AMENDMENTS TO THE DRAWINGS

REMARKS

Serial No. 10/508,811
Docket No. 02635/0201896-USO

New Sheet

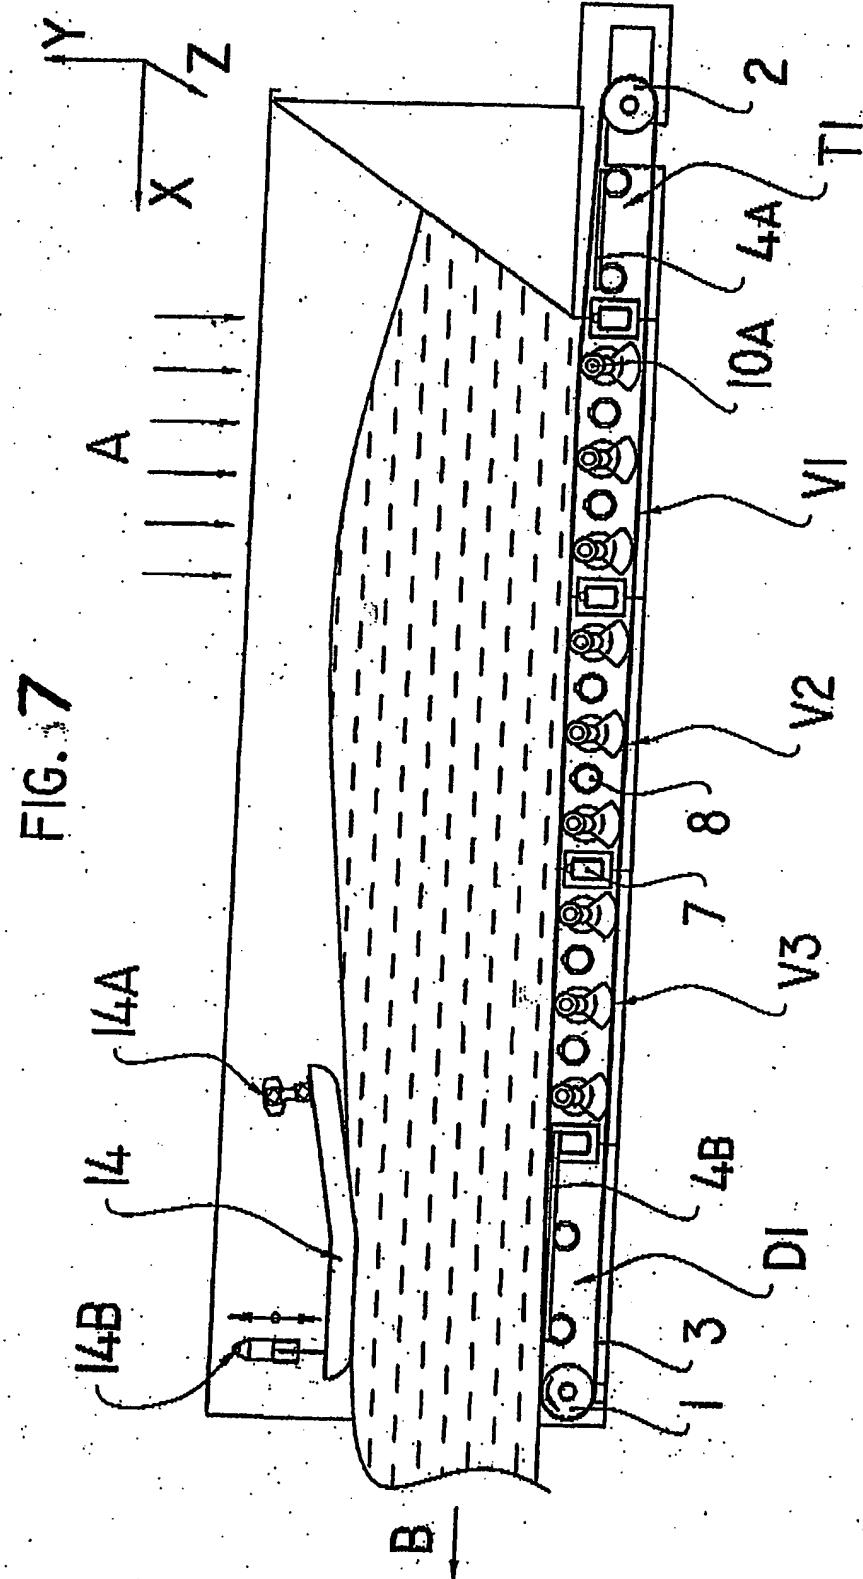
A corrected Fig. 6 is submitted. Also, a new Fig. 7 is added to show the pressure plate.
